2.0 PROJECT DESCRIPTION COMMENTS AND RESPONSES

STATELINE RETAIL CENTER

Figure 2-1: Layout and Landscape Plan
 Town of Southeast, Putnam County, New York
 Source: Insite Engineering, Surveying & Landscape Architecture, P.C.
 Revision Date: 11/24/08
 Scale: Graphic

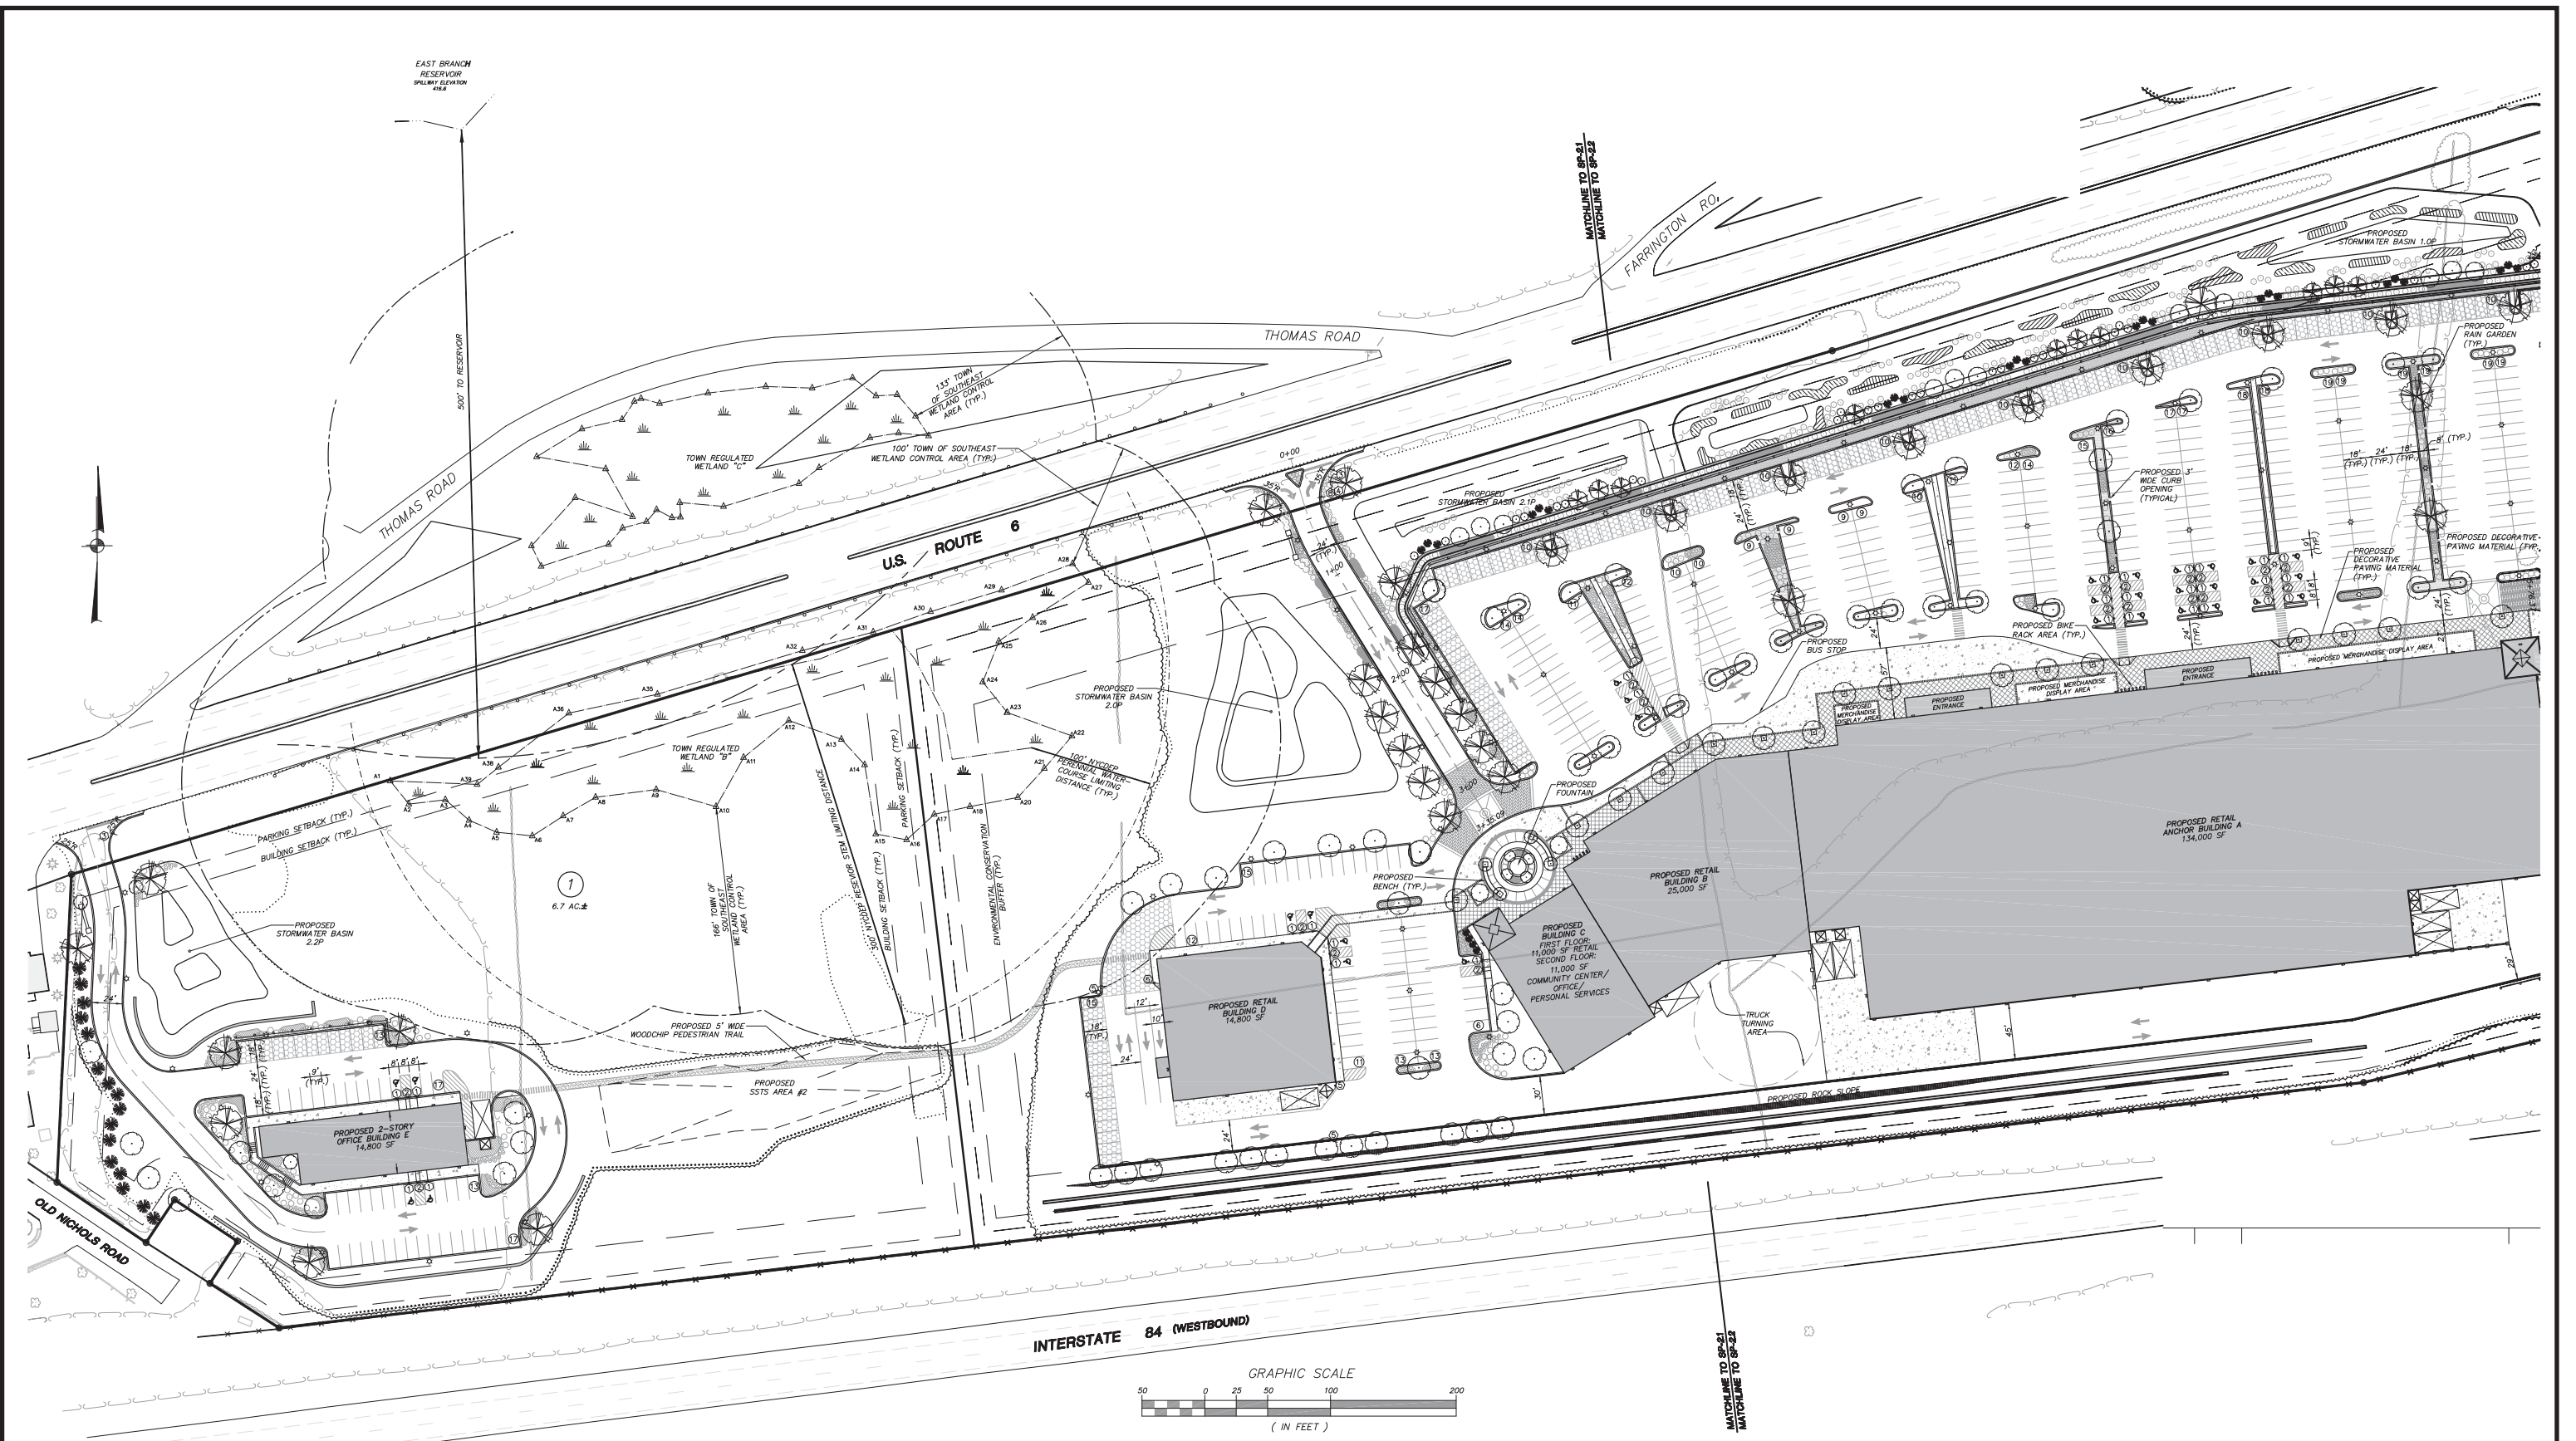
Comment 2.0-1 (Mr. Phil Wissel, Public Hearing, July 14, 2008): I notice that nowhere in any of the renderings when I looked at the front facade or the front approach to the building; it was a nice, beautiful walkway and all. There was no clutter of outdoor displays or outdoor storage. A lot of times these shopping centers look nice in the beginning then all of a sudden a new delivery comes in, have the pallets stacked high, people have to walk around it. Can I assume that since there's nothing in those renderings of that nature, that you would have no objection to a restriction of no outdoor storage in the front of the buildings? I'm talking about if we go to Home Depot, we see 20 tractors sitting out front where people normally would walk because it's easier to leave them there and have people take them right off the front of the building where it is out there instead of going in, having them all stored in the back of the building or someplace else. What good is this beautiful, nice walkway, trellises and building, nice facade, if you're going to have all this stuff stored in direct byline to the building? **[A similar comment was voiced by Ms. Lynne Eckhart, Public Hearing, August 11, 2008.]**

Comment 2.0-5 (Mr. Dave Rush, Public Hearing, July 14, 2008): [I]s there any thought in connecting the office area to the mall for people who need to walk from point A to point B? Am I going to get into my car to drive around to the mall or have you thought about connecting the buildings at all?

Comment 2.0-15 (Ms. Lynn Eckhart, Public Hearing, July 14, 2008): Also, it is said that there could be a fountain; there could be different paving. It would be nice to pin some of that down; a fountain sounds a lot more appealing, I'm sure to some of us, than different paving.

Response 2.0-1: The modified site plan includes three areas in which retailer(s) may choose to display merchandise. The three merchandise display areas are sized as follows:

- *The western display area is approximately 15' x 35' (525 s.f. +/-)*
- *The middle display area is approximately 15' x 80' (1,200 s.f. +/-)*
- *The eastern display area is approximately 15' x 155' (2,325 s.f. +/-).*

The sidewalk just to the east of the smallest display area is 57 feet from the building to the access road and its width at the middle and eastern display areas is 27 feet from the building to the access road. The proposed sidewalks provide visual continuity across the entire front of the main retail building as well as safe passage for pedestrians across an area no less than 12 feet in width where the merchandise display areas are proposed. The merchandise display areas would not be used for the storage of deliveries or boxed/crated materials. Refer to Figure 2-1 and Drawing No. SP-2.1 attached to this FEIS for depictions of the proposed merchandise display areas and the surrounding sidewalks.

***Response 2.0-5:** The modified plan includes an approximately 460 foot long five foot wide foot path of wood chips linking the office building with the retail development. Refer to Figure 2-1 and the plan set Drawing No. SP-2.1 for depictions of the proposed foot path.*

The size and configuration of the proposed merchandise display areas and the wide walkway in front of the building provide ample room (12 feet plus of unencumbered side walk) for pedestrians to pass safely without having to enter the flow of traffic passing the front of the building. Refer to Figure 2-1, Layout and Landscape Plan and Drawing No. SP-2.1 attached to this FEIS for a depiction of the proposed merchandise display areas and the surrounding sidewalks.

Response 2.0-15: *Landscaping and decorative paving will be incorporated into the proposed development along with other architectural and visual features. Refer to Figures 2-1 and 2-14 for examples of landscaping and paving, Figures 2-3, 2-4, 2-5 and 2-6 for architectural features as well as FEIS plan Drawing Nos. SP-2.1 and SP-2.2 and Appendix D herein.*

Figure 2-2: I-84 Sign Element View
U.S. Route 6, Town of Southeast
Putnam County, New York
Source: DCAK-MSA Architecture, 06/24/09
Scale: As shown

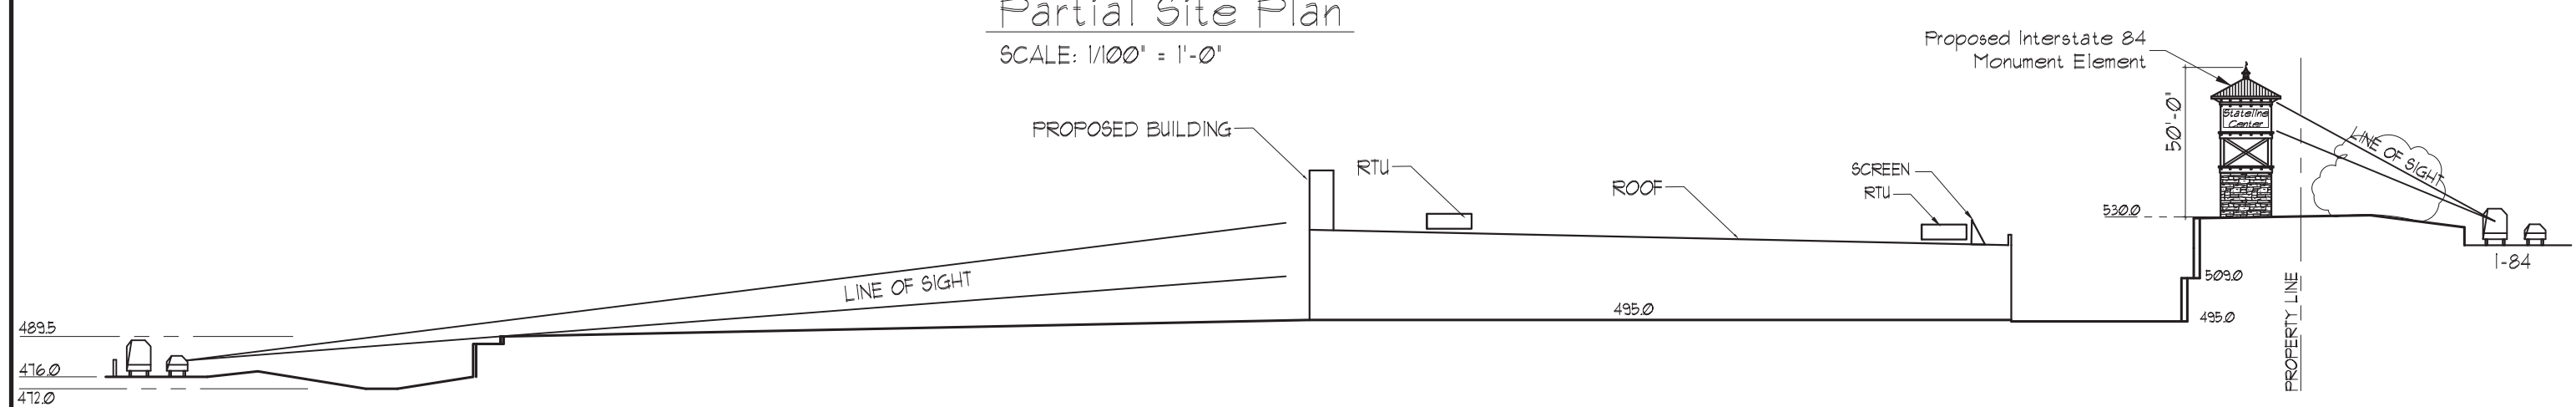
Comment 2.0-2 (Mr. Dave Rush, Public Hearing, July 14, 2008): How high is the top of the tower?

***Response 2.0-2:** The height of the proposed architectural elements (towers) proposed for the front and rear of the buildings is a maximum of 50 feet. This complies with Town Code requirements.*

An architectural element, designed to reflect the building architecture and sited near the southern property line along Interstate 84, is proposed to mark the location of the retail center for passing motorists. This feature will also measure fifty feet in height and thereby comply with the Town code. Refer to Figure 2-2, Interstate 84 Sign Element View.

Figure 2-3: Building Elevations
Stateline Retail Center
Town of Southeast, Putnam County, New York
Source: DCAK-MSA, 03/09/09
Scale: NTS

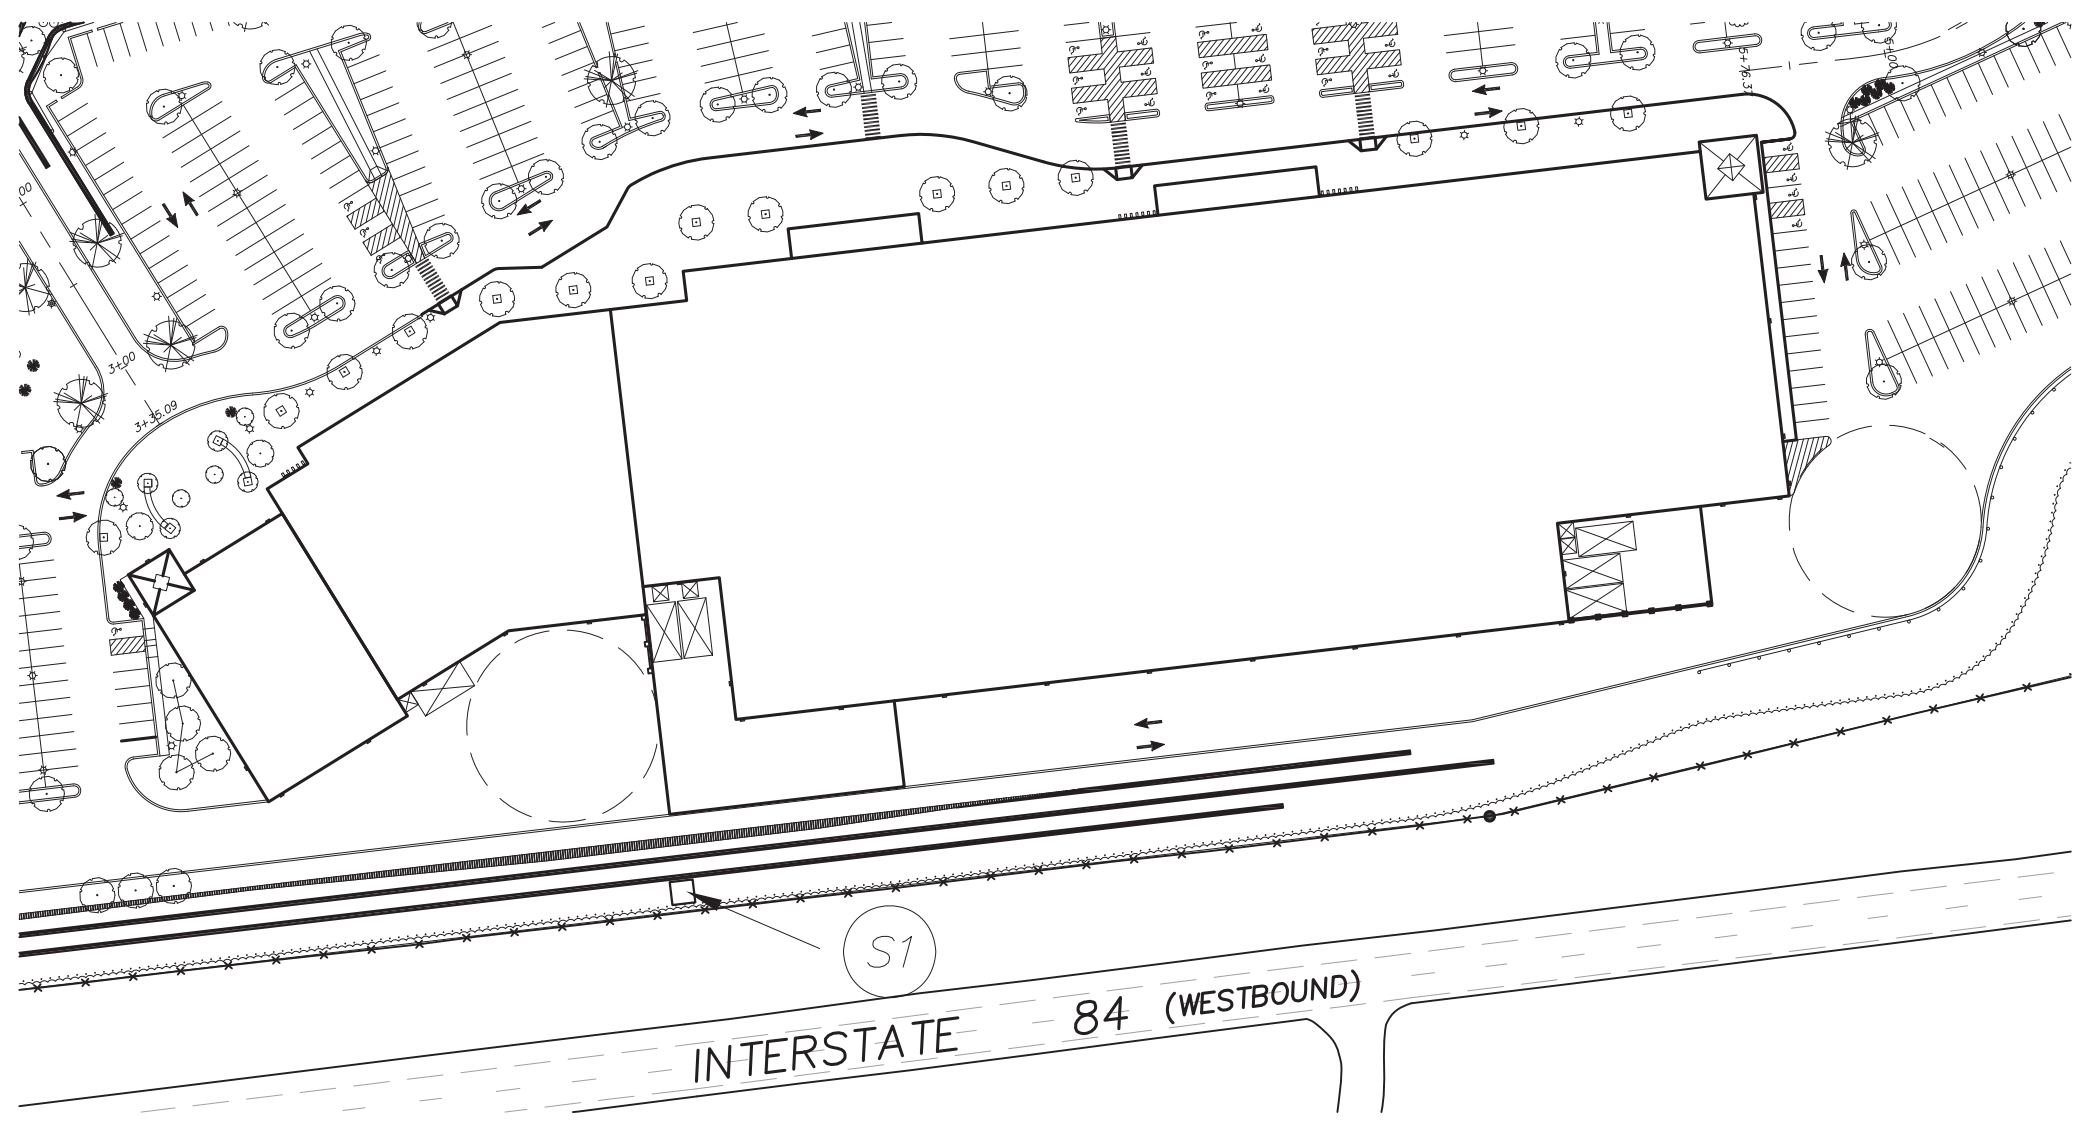
Comment 2.0-9 (Mr. Dan Armstrong, Public Hearing, July 14, 2008): How much latitude is in the overall design? How much [latitude] are they [the tenants] going to have? And that's assuming you don't have tenants when this gets approved. You know, Home Depot or Kohl's is another one where they have a design that they use all over the place, and they will modify slightly. But we're talking here about kind of putting a lot of time into it, into a whole series of elements that may not fit with their image of their store, the corporate image...I don't know how you're going to make all that work with a variety of tenants unless you're going to be able to negotiate with them and say this is it, take it or leave it, because from my understanding, whatever is approved as part of the DEIS or the final EIS, that's what's going to have to be built. This is what you're presenting now but your tenants or whatever, economics makes you, forces you to do something different. **[A similar comment was voiced by Ms. Lynne Eckhart, Public Hearing, August 11, 2008.]**

Comment 2.0-10 (Mr. Dan Armstrong, Public Hearing, July 14, 2008): My understanding is that the ordinance says that you must treat all facades with the same architectural treatment. So there has to be some kind of treatment of the facade that faces 84...you did show the side facade.

Response 2.0-9: The modified plan includes a variety of architectural elements that will be incorporated throughout the proposed development; refer to Figures 2-3, 2-4, 2-5,

2-6 and the drawings contained in Appendix D herein for a complete set of building elevations developed by the project architect. Similar to any other Town requirement, the architectural features will be an enforceable element of the project through the new zoning law and conditions set forth in the special permit (Section 138-63.4 of the Town Code).

Response 2.0-10: *All facades will be developed with a similar theme based on the kit of parts presented in the DEIS with the modifications noted herein and in compliance with zoning ordinance and special permit conditions. The project architect has refined the elements proposed for the retail center by choosing specific kit of parts features and applying them universally throughout the development. For example, the use of colored, standing seam metal roofs coupled with asphalt shingles and dormers breaks up the roof line and evenly spaced columns interspersed amongst a variety of window features, a mix of siding types and grand storefront entrances such as gazebos, towers and silos provide a unique and visually appealing facade. Refer to Figure 2-3, 2-4, 2-5, 2-6 and Appendix D herein for building elevations, architectural treatments and other development details.*

Refer to Figures 2-7, 2-8, 2-9, 2-10 and 2-11 (originally presented in the DEIS) and Figure 2-2 for a series of sight-line drawings into the project site from various vantage points along Interstate 84. The three dimensional animation contained in Appendix C and offered on the Town website provides views of the developed project from the perspective of vehicle occupants traveling both east and west on Interstate 84. Due to the limited visibility into the site from the highway, motorists will not see the rear of the proposed buildings. Nonetheless, while not as articulated as the front, the Applicant and the project architect have included architectural treatments including towers, columns, standing seam metal roofs and a variety of building materials and colors, for employees and delivery vehicle drivers who will travel to the rear of the buildings. Note, patron parking and traffic are not proposed for the rear of the building. Figures 2-3 and 2-6 depict views of the rear of these buildings.
